**Independent Review of  
Greenhouse Gas  
Assessments**

Bayswater B EA Concept  
plan

Bayswater B EA Concept  
plan

October 2009

**Figure 3 Indicative LRMC excluding carbon price**

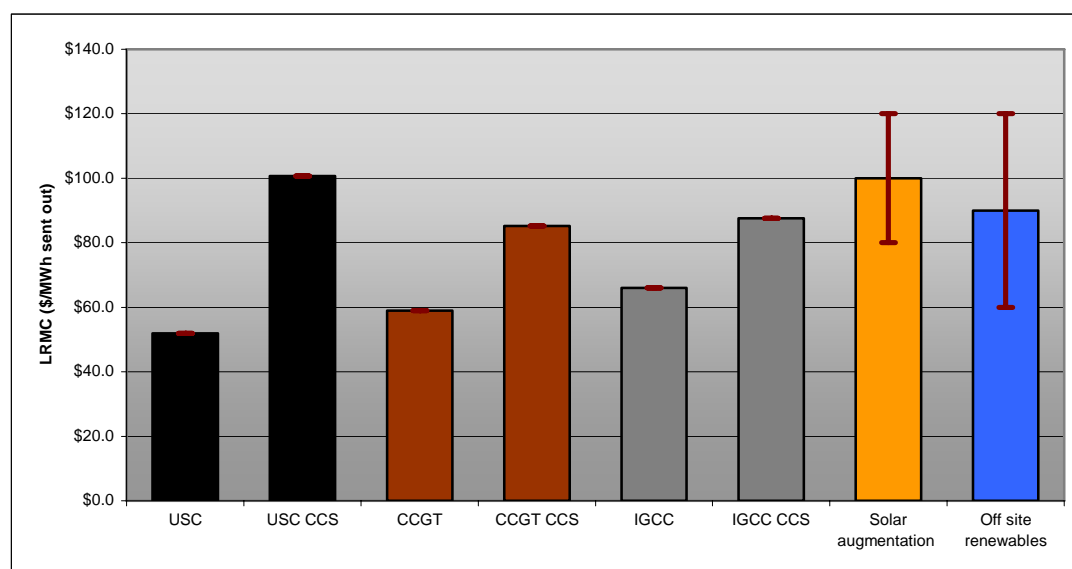
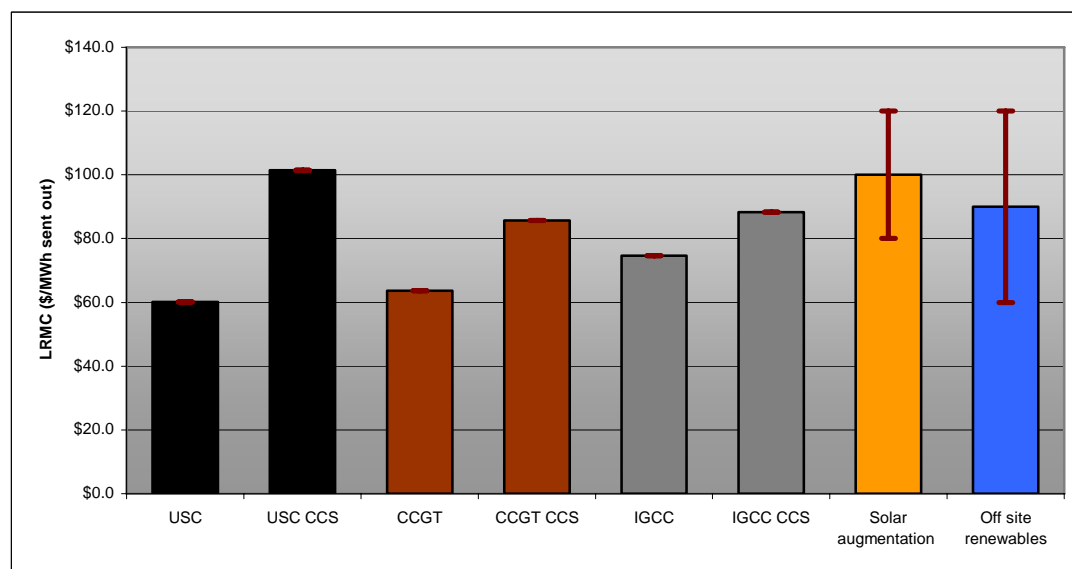
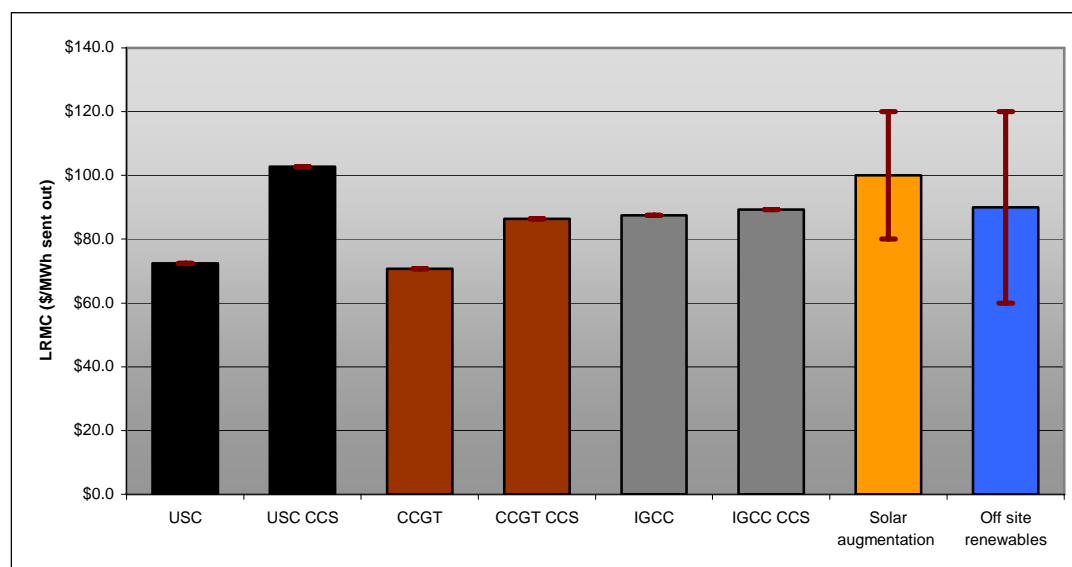
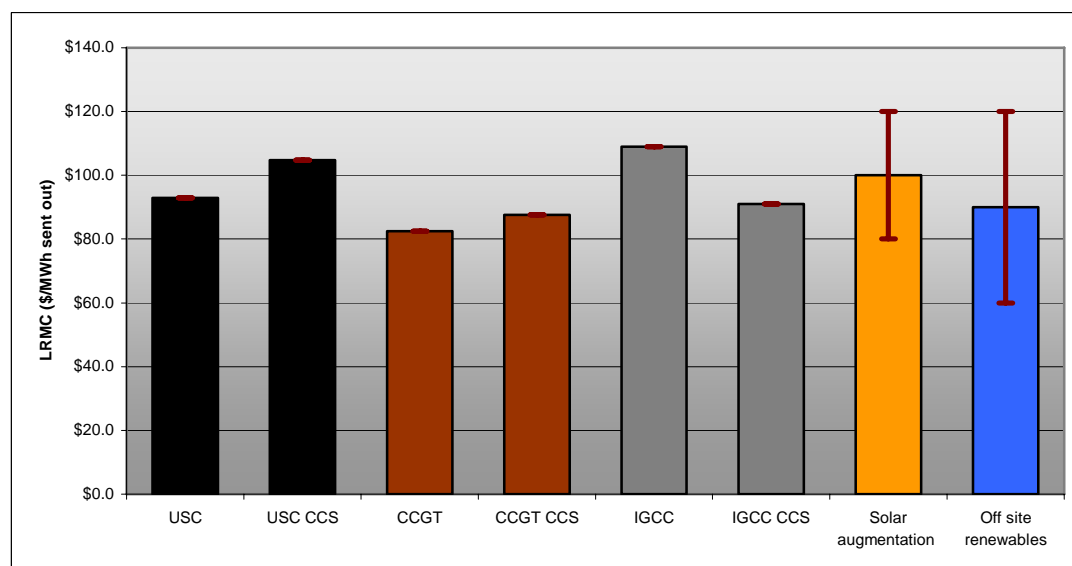
While Figure 3 to Figure 6 above are indicative only, they show that the gas fired option becomes more viable than the coal fired option at a carbon price of less than \$25 per tonne. They also show that solar augmentation may be just as viable as CCS technology. These conclusions are based on generic preliminary data as well as data taken from the GHG assessment which as discussed throughout this review contain several weaknesses. In order to support these conclusions a more thorough analysis LRMC of options is required.
